CITY PLAN COMMISSION STAFF REPORT

CD-CPC-2025-00168

9th and Central

Request
Rezoning to UR and Development Plan

TREE REMOVAL PLAN

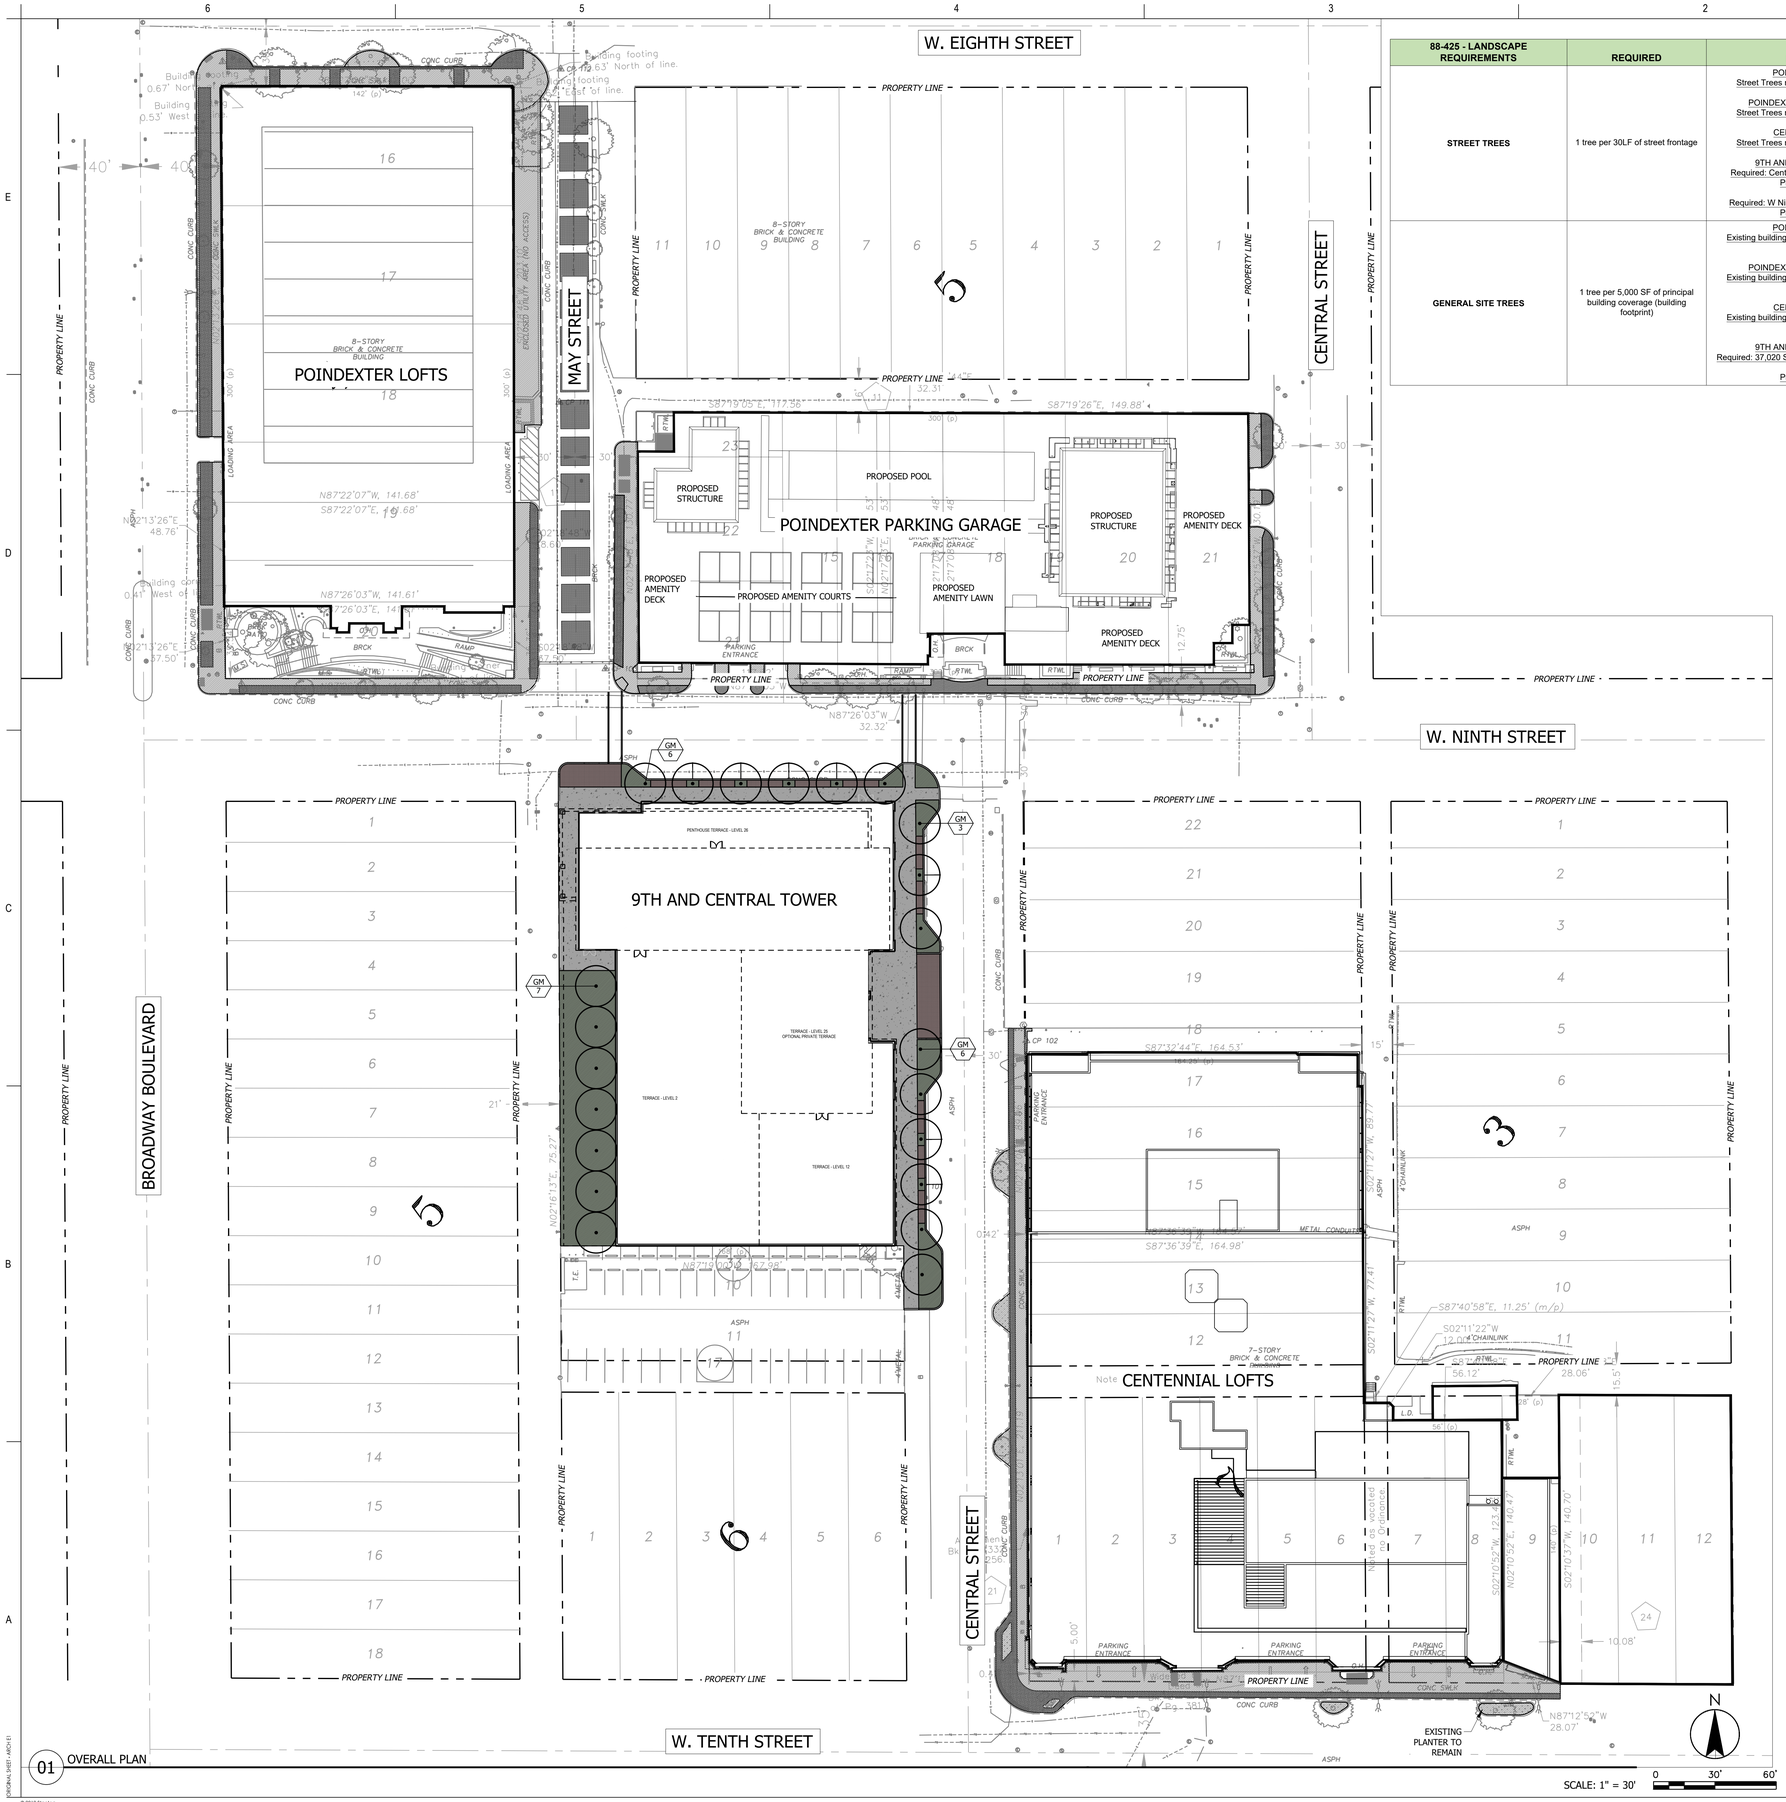
The plan identifies trees to be removed on the 9th and Central Tower site, all trees on site will be removed.

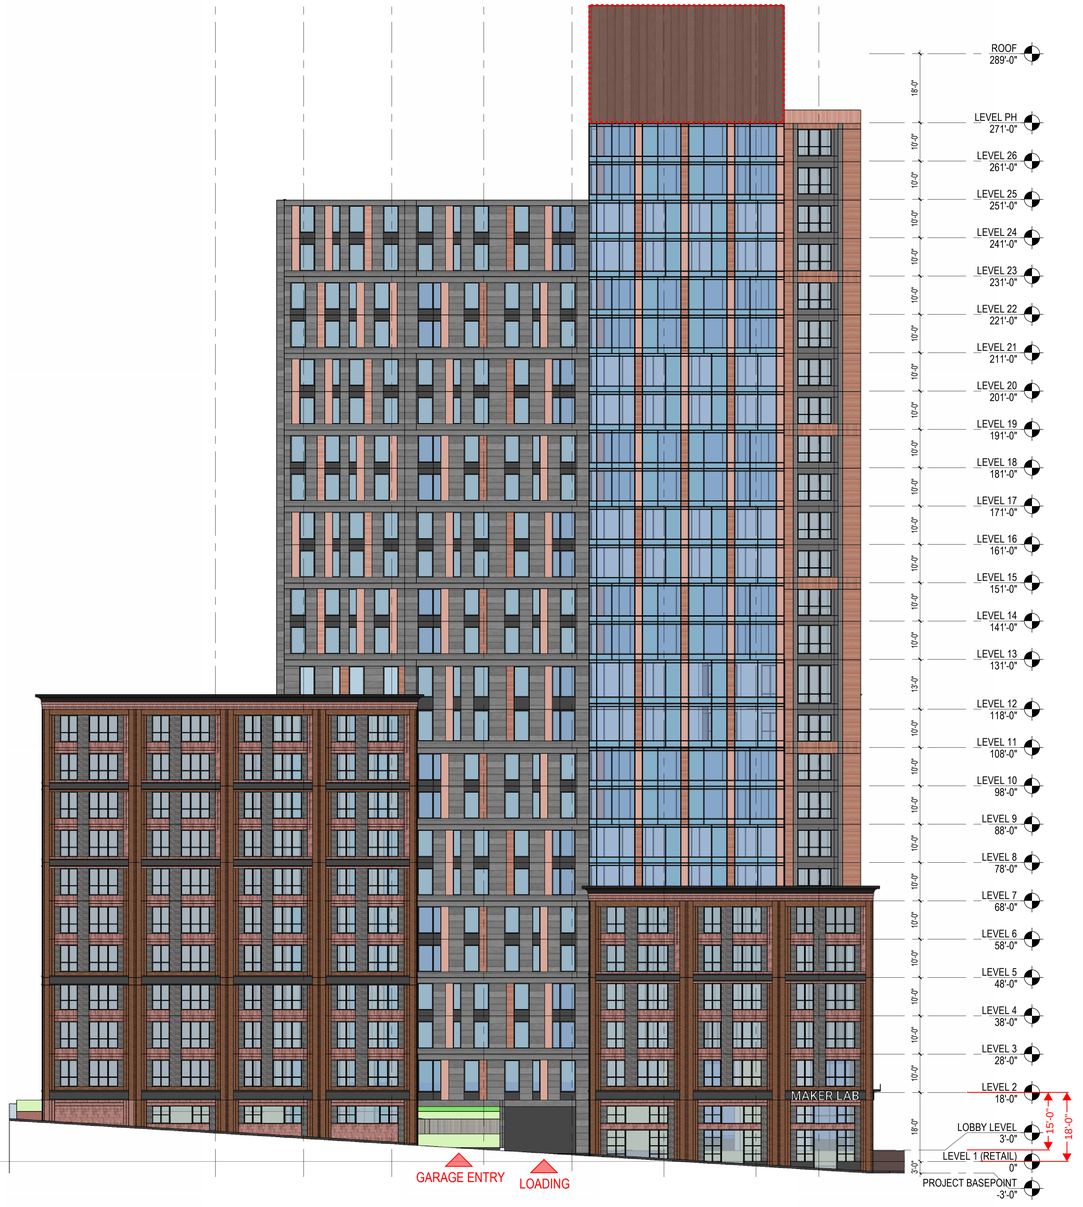
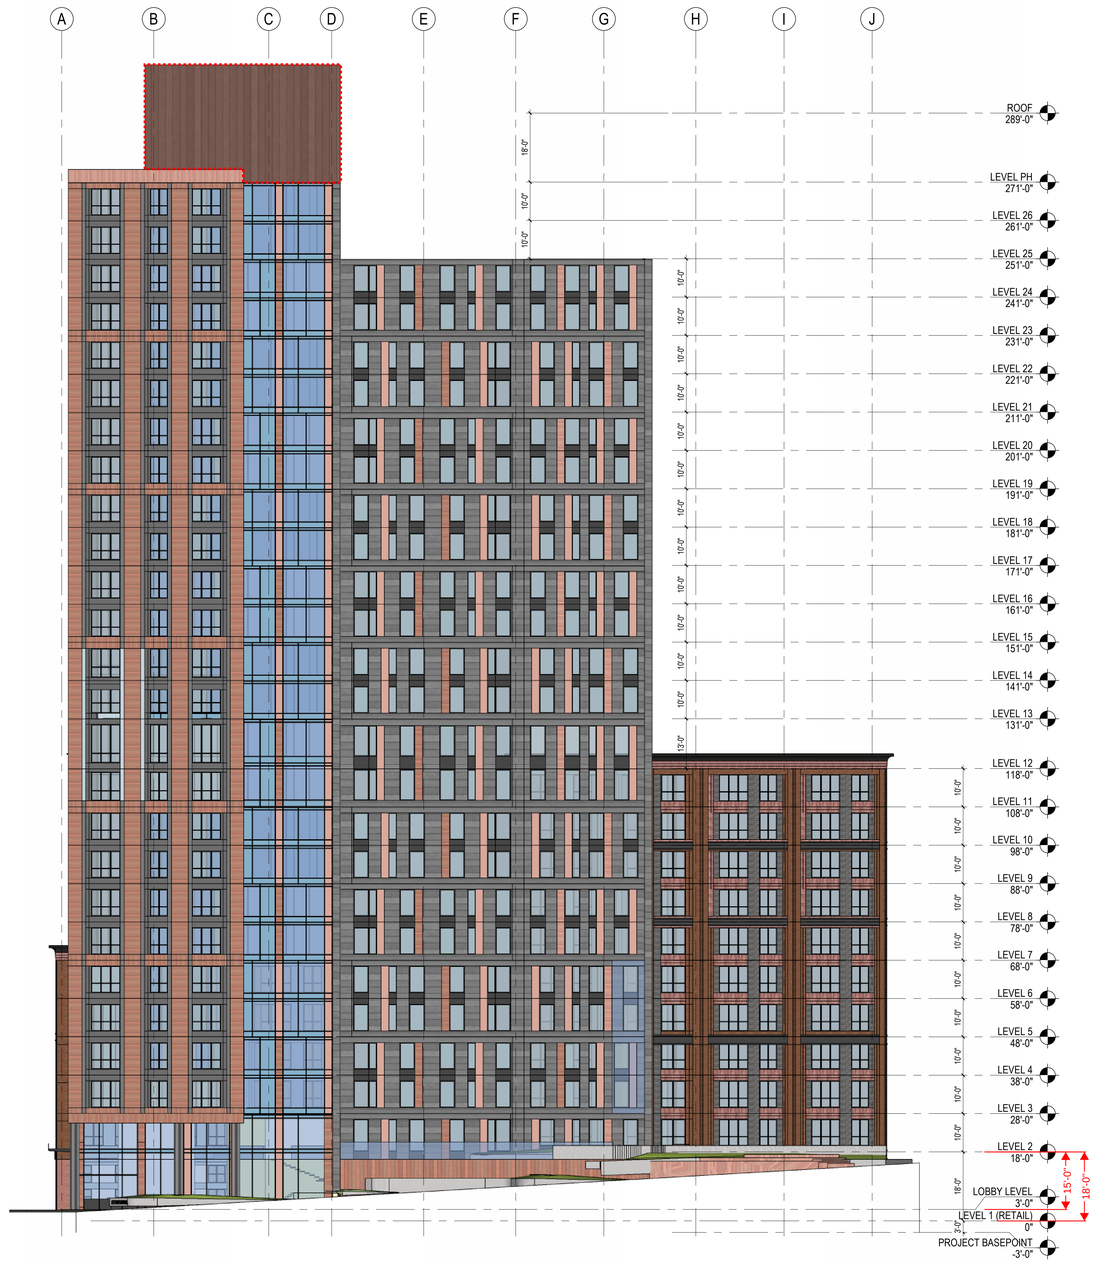
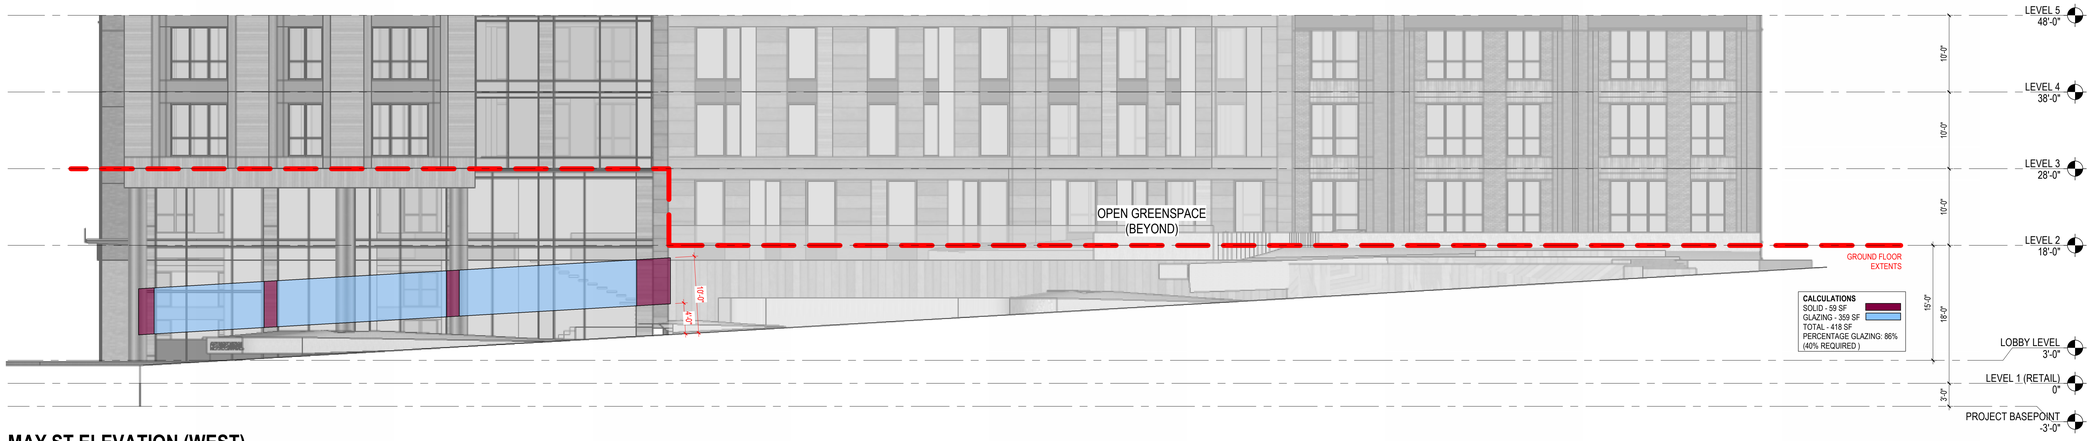
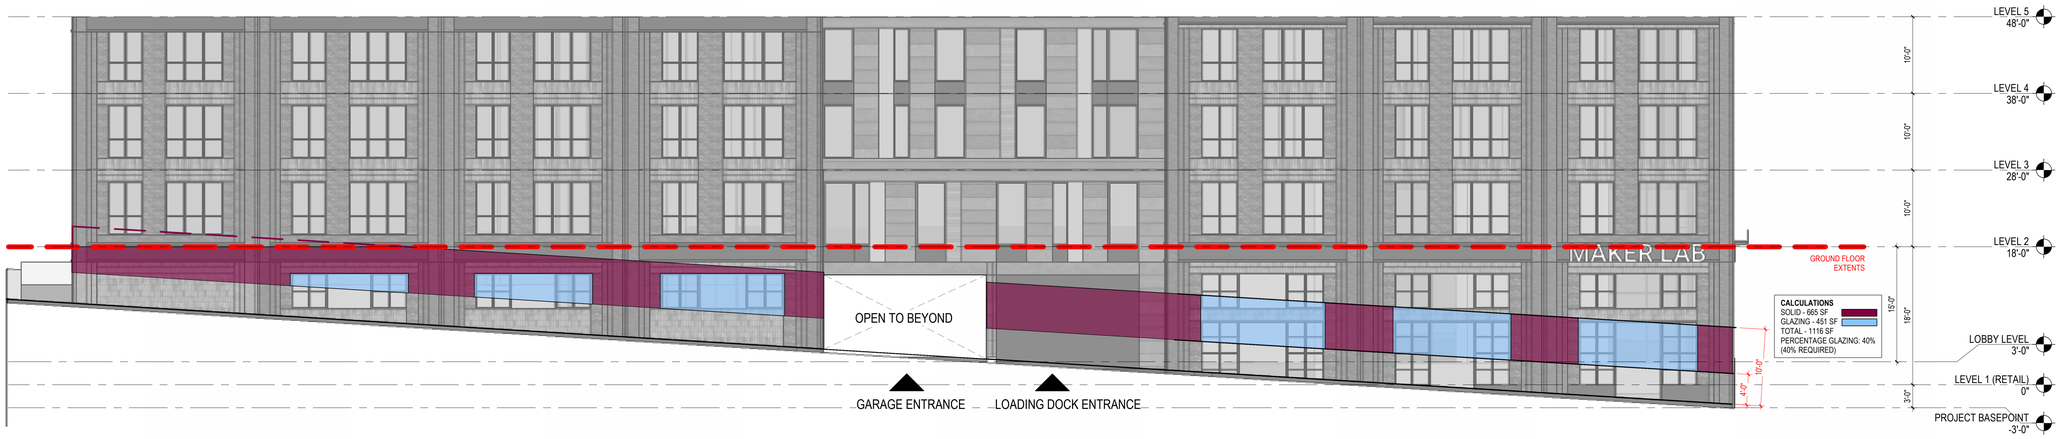
The 9th and Central building appears to be constructed of varying colors of brick and metal panels, which will match much of the surrounding area. Staff is including a condition that the construction materials be added to the elevation sheets prior to ordinance request (Condition 10).

The Pointdexter Lofts, Pointdexter Garage, and Centennial Lofts are all comprised of brick with accent detailing. The proposed 9th and Central building appears to be constructed of varying colors of brick and metal panels. Staff added a condition requiring the applicant to list the construction materials prior to ordinance request (Condition 10). The applicant worked with staff to update the materials on the roof level of the building to include colors that more closely resemble the existing building and the surrounding area.
